SUBDIVISION REVIEW SHEET**CASE NO.:** C8-2016-0004.0A**P.C. DATE:** April 11, 2017**SUBDIVISION NAME:** Resubdivision of Lots 2 & 3, of the resubdivision of Lots 1 & 2,
J.D. Horne Addition**AREA:** 0.61 acres**LOT(S):** 3**OWNER/APPLICANT:** Bodhi Group, LLC
(Yusuf Johnson)**AGENT:** Land Answers, Inc.
(Jim Wittliff)**ADDRESS OF SUBDIVISION:** 4016 Valley View Rd.**GRIDS:** G19**COUNTY:** Travis**WATERSHED:** West Bouldin Creek**JURISDICTION:** Full**EXISTING ZONING:** SF-3-NP**NEIGHBORHOOD PLAN:** South Lamar (suspended)**PROPOSED LAND USE:** Single-Family

RESUBDIVISION OF LOTS 2 & 3, OF THE RESUBDIVISION OF LOTS 1 & 2, J.D. HORNE ADDITION

SUBJECT: C8-2016-0004.0A Resubdivision of Lots 2 & 3, of the Resubdivision of Lots 1 & 2, J.D. Horne Addition

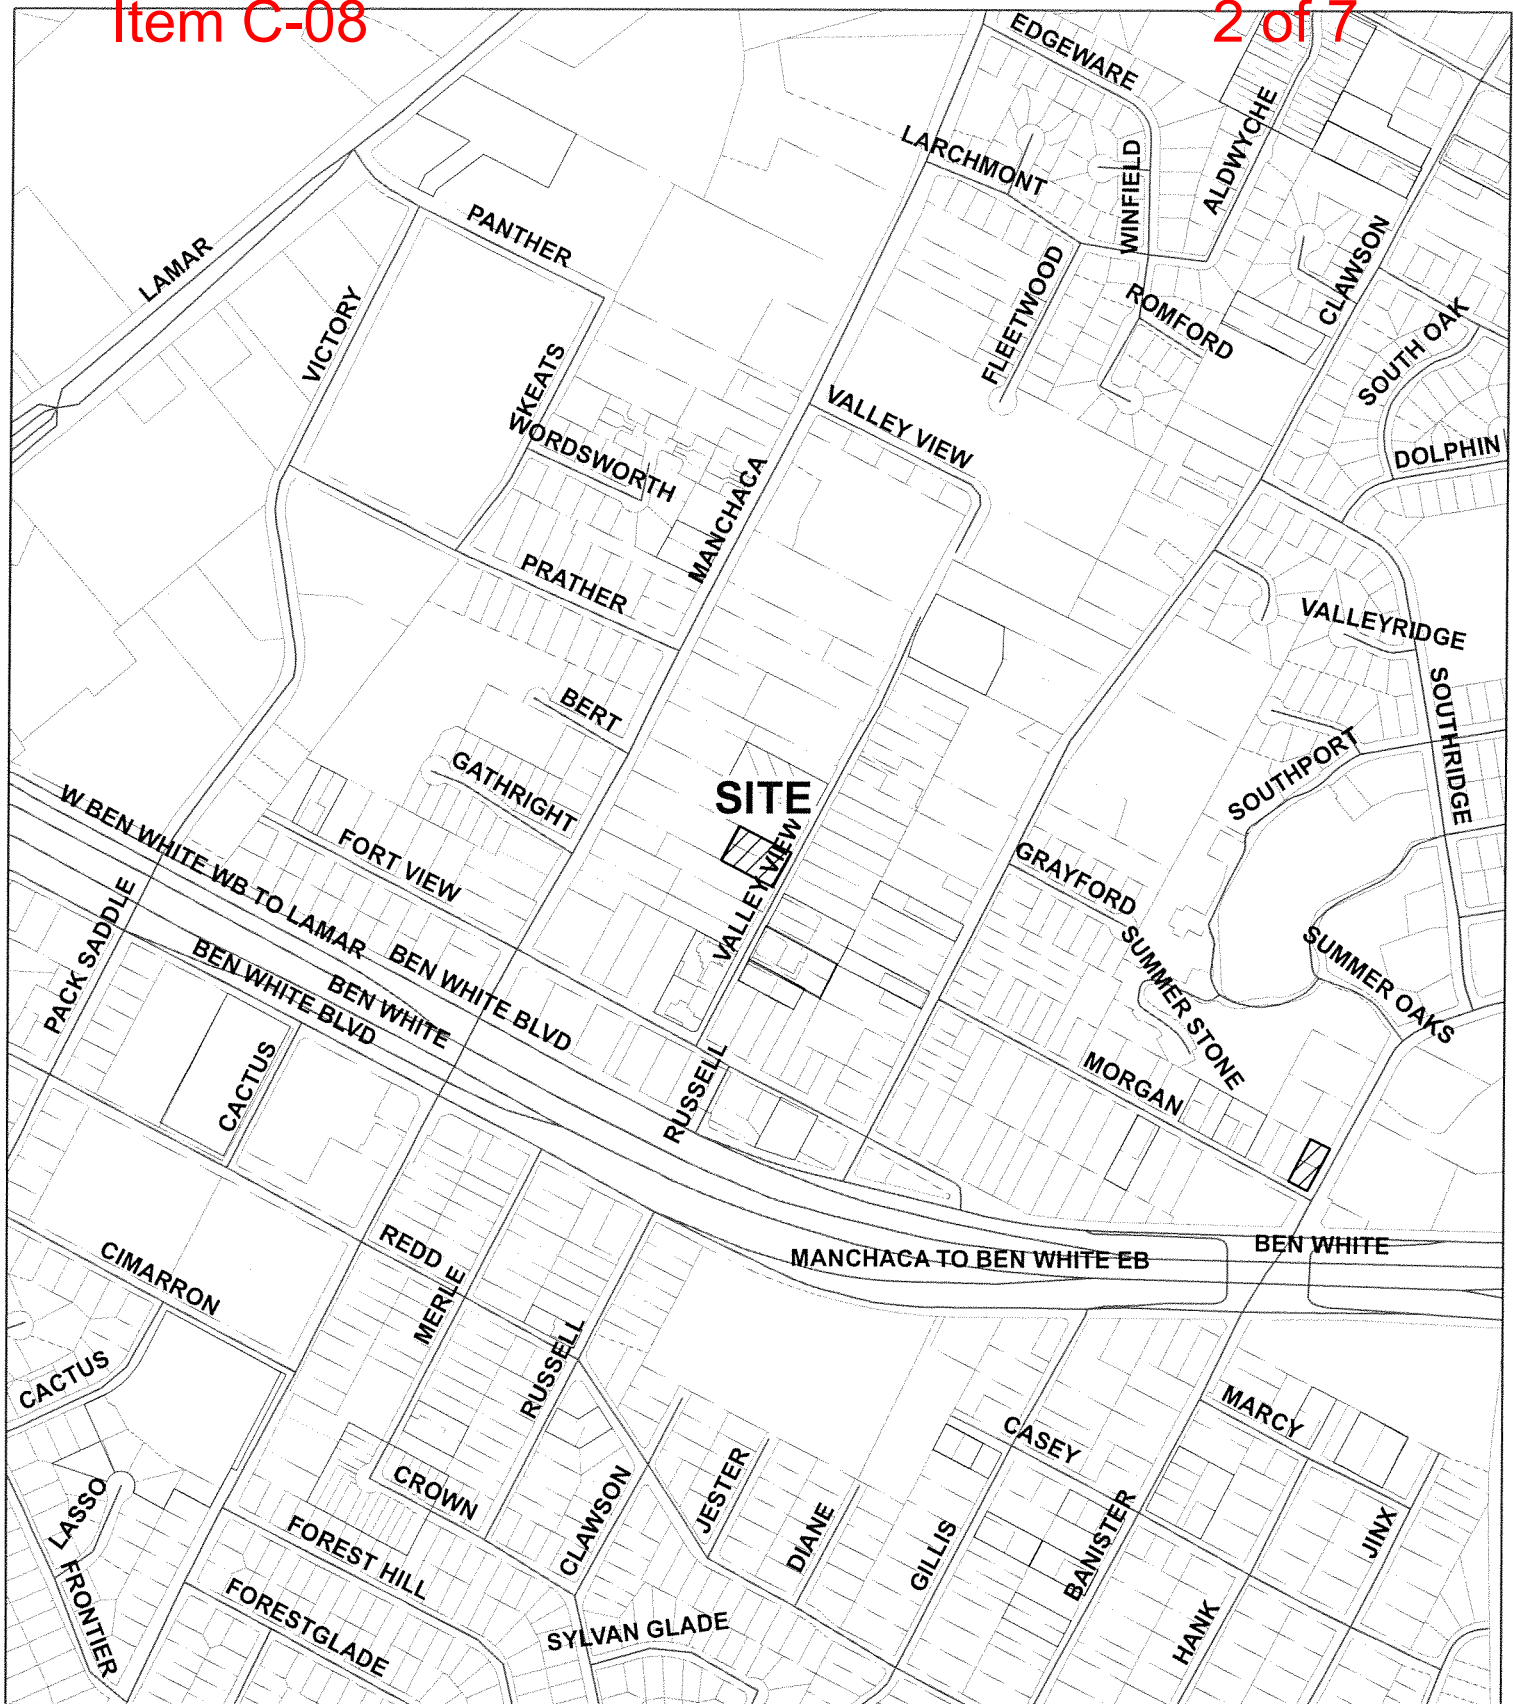
VARIANCES: A variance to section 25-4-175 to allow a residential flag lot(s) has been requested. The applicant is proposing one residential flag lot with this application. The applicant has obtained approval from the Fire Department to verify accessibility for emergency responders, approval from the Austin Water Utility, Austin Energy, and the City Arborist to verify there is adequate room for the required utilities and enhanced tree protection on the site. It is Staff's opinion that the proposed subdivision is compatible with the surrounding development, and is consistent with other flag lots within the neighborhood. It should also be noted that there are no known deed restrictions on the site, and a note has been added that requires all addresses for residential lots utilizing a flag lot design must be displayed at their closest point of access to a public street for emergency responders. Because the application meets the flag lot criteria as required by the Land Development Code, the Staff recommends approval of the variance.

DEPARTMENT COMMENTS: The request is for the approval of the Resubdivision of Lots 2 & 3, of the resubdivision of Lots 1 & 2, J.D. Horne Addition subdivision composed of three lots on 0.61 acres. The applicant is proposing to resubdivide two existing lots into a three lot subdivision for residential uses.

STAFF RECOMMENDATION: If the variance is approved, the staff recommends approval of the plat. With variance approval, this plat would meet all applicable State and City of Austin LDC requirements.

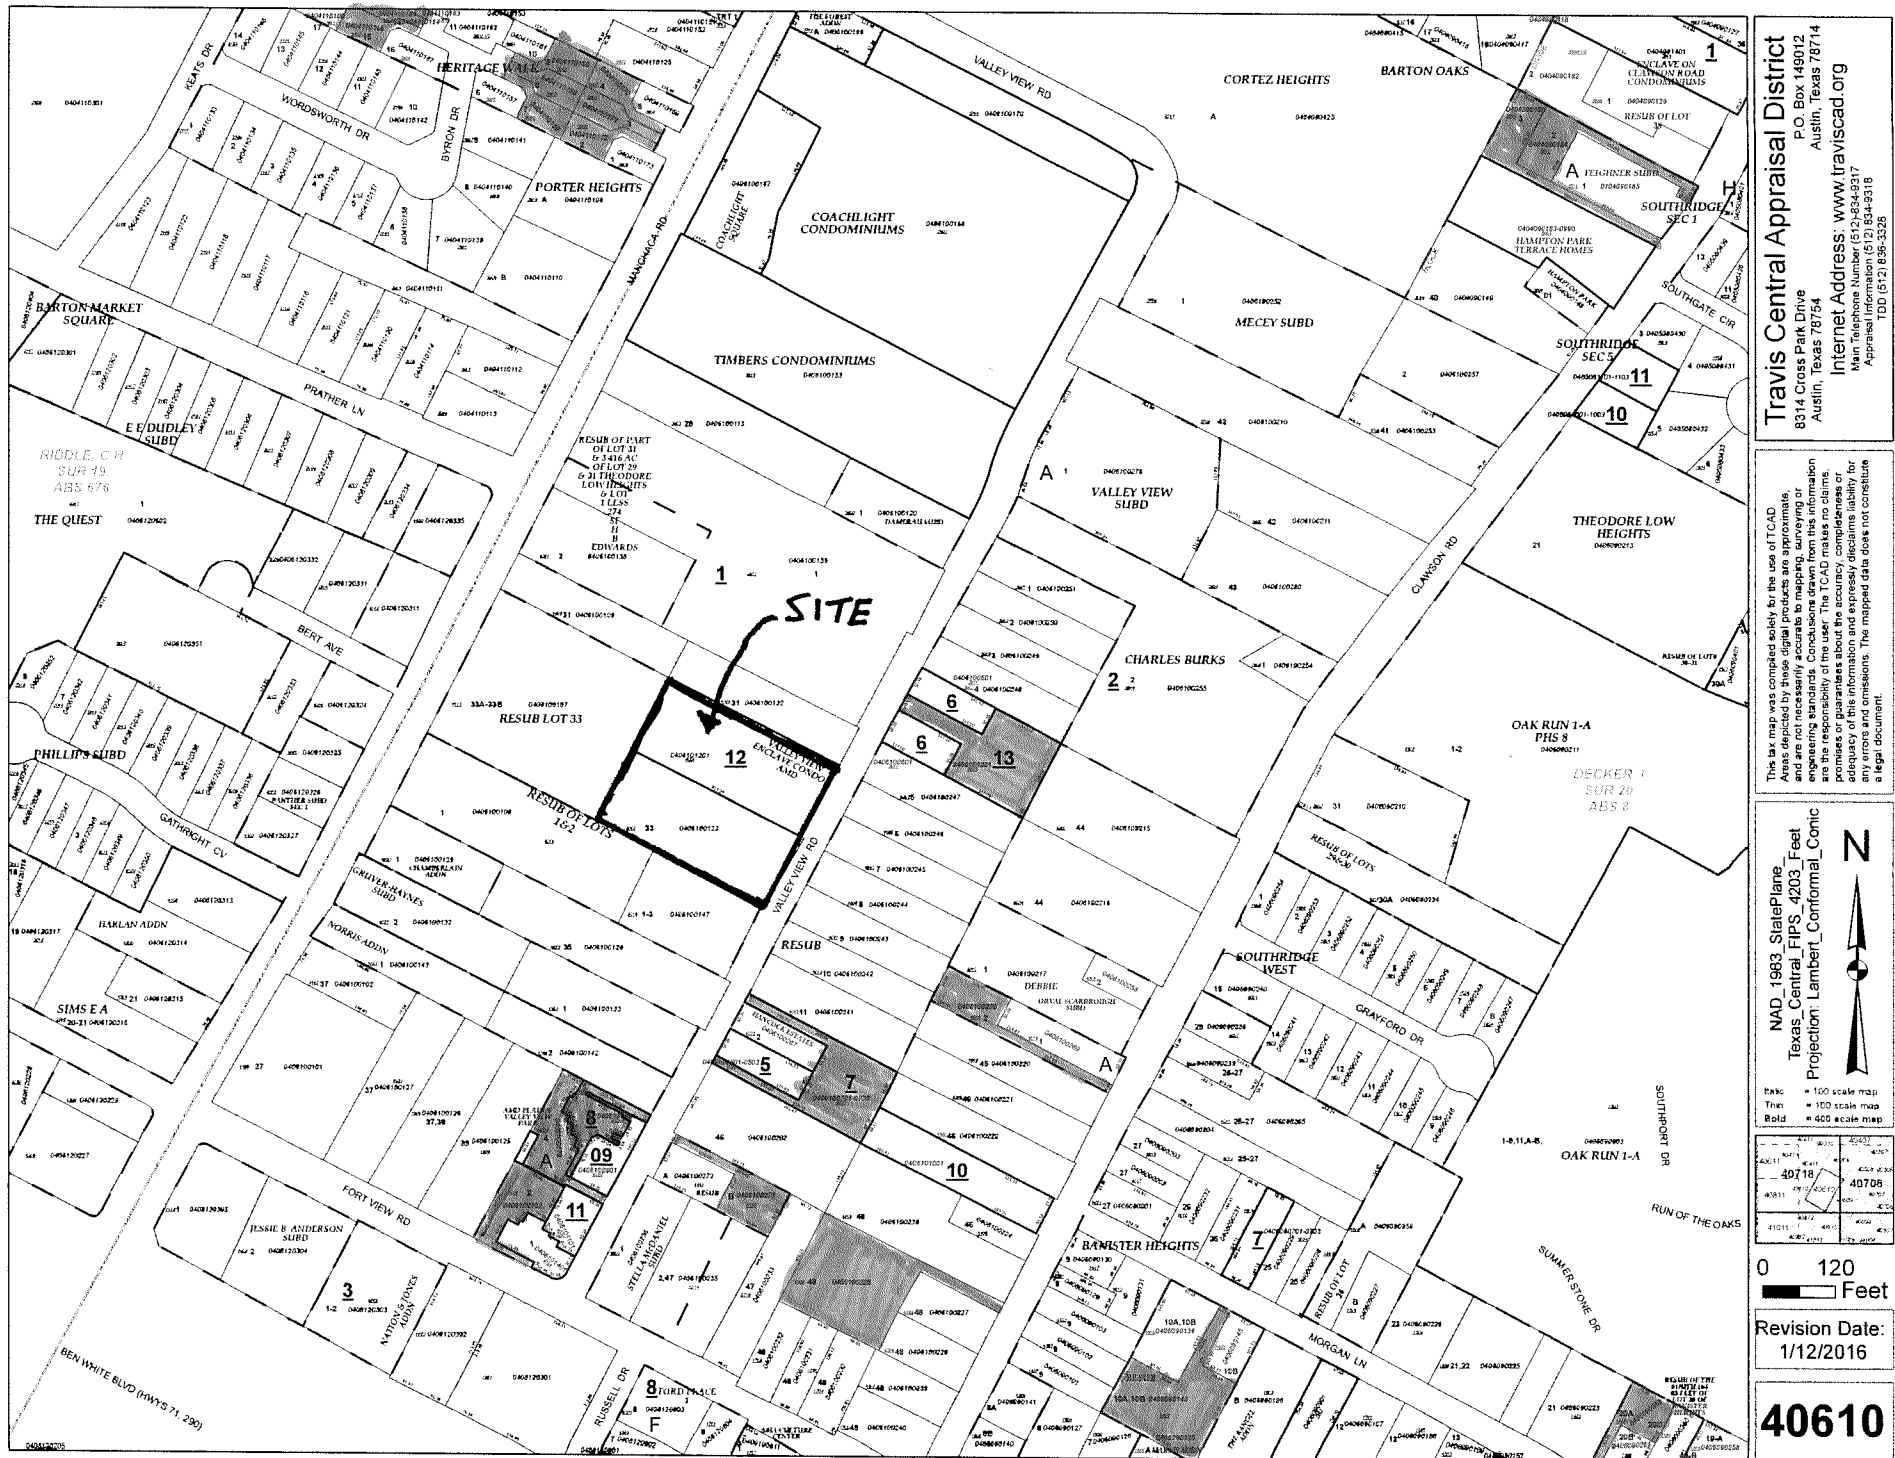
Other lots fronting Valley View Rd. have been subdivided using the flag lot configuration. North of this property at 3913 & 3915 Valley View Rd. and south of this property at 4025 through 4201 Valley View Rd. the properties have been resubdivided as flag lots. Additionally, lots at the intersection of Fort View Rd. and Valley View Rd have been resubdivided as flag lots, as well as lots fronting the road east of the property on Clawson Rd.

The immediate area is zoned SF-3 which is the appropriate zoning for the proposed use and follows the Imagine Austin compact city principle. See attached, Surrounding Neighborhood Exhibit which generally shows the development pattern in the immediate vicinity..
